**STAFF RECOMMENDATION**  
**108 Rosebank Avenue**  
**December 18, 2019**

**Application:** Setback determination  
**District:** Eastwood Neighborhood Conservation Zoning Overlay  
**Council District:** 06  
**Base Zoning:** R6  
**Map and Parcel Number:** 08303018400  
**Applicant:** Cheyenne Smith  
**Project Lead:** Melissa Baldock, melissa.baldock@nashville.gov

<p><b>Description of Project:</b> Application is for a setback determination for an addition that was previously approved by the Metro Historic Zoning Commission. Base zoning requires a five foot (5') side setback and the applicant is proposing a side setback of approximately two feet, ten inches (2'10"). The addition's design, including its height, scale, roof form, proportion and rhythm of openings, orientation, and materials, have not changed since the Commission approved the project in April 2019.</p> <p><b>Recommendation Summary:</b> Staff recommends approval of the setback finding that it meets Sections II.B. of the design guidelines for the Eastwood Neighborhood Conservation Zoning Overlay.</p>	<p><b>Attachments</b> <b>A:</b> Site Plan <b>B:</b> Elevations</p>
--	--

**SITE PLAN**  
**108 ROSEBANK AVENUE**  
 TAX MAP 083030-18400  
 NASHVILLE, TENNESSEE

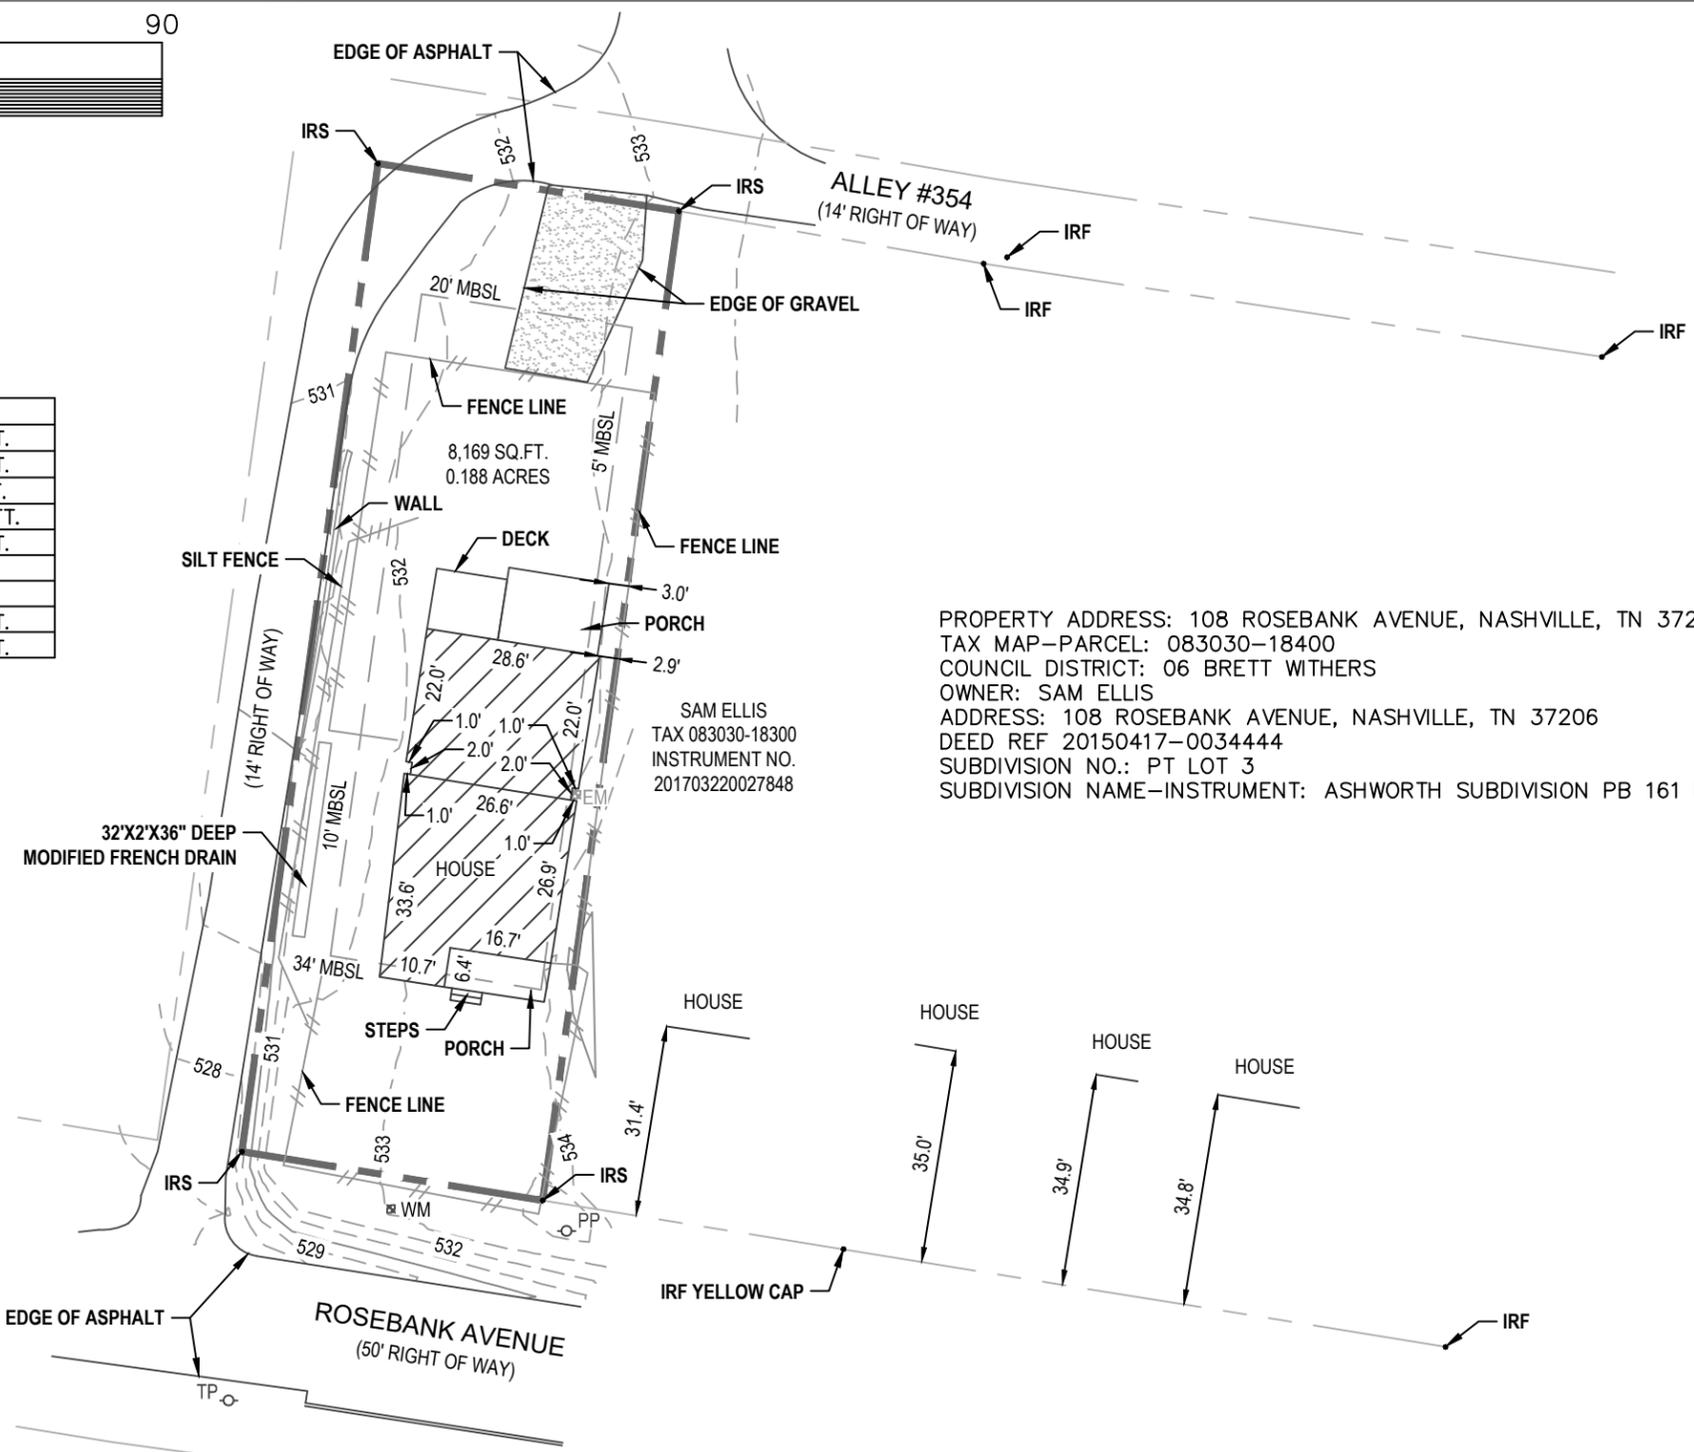
**Setback & Rhythm of Spacing:** The house is over seventy feet (70') from the rear property line, meeting the base zoning twenty foot (20') rear setback. The house is shifted on the lot so that it is approximately nineteen feet (19') from the left side property line but just two feet, ten inches (2'10") from the right side property line. After an inset, the addition will line up with the side wall of the house; therefore it too will not meet the five foot (5') base zoning setback and will just be two feet, ten inches (2'10") from the side property line. Staff finds the proposed right side setback determination to be appropriate because addition will be no wider than the historic house and will not

encroach further on the side property line than the current house. The Commission has approved side setback determinations in similar situations where the historic house does not meet the base zoning setback and the addition is no wider than the historic house.

Staff finds the addition's setback and rhythm of spacing to meet Section II.B.1.c. and II.B.2. of the design guidelines.

**Recommendation Summary:** Staff recommends approval of the setback finding that it meets Sections II.B. of the design guidelines for the Eastwood Neighborhood Conservation Zoning Overlay.
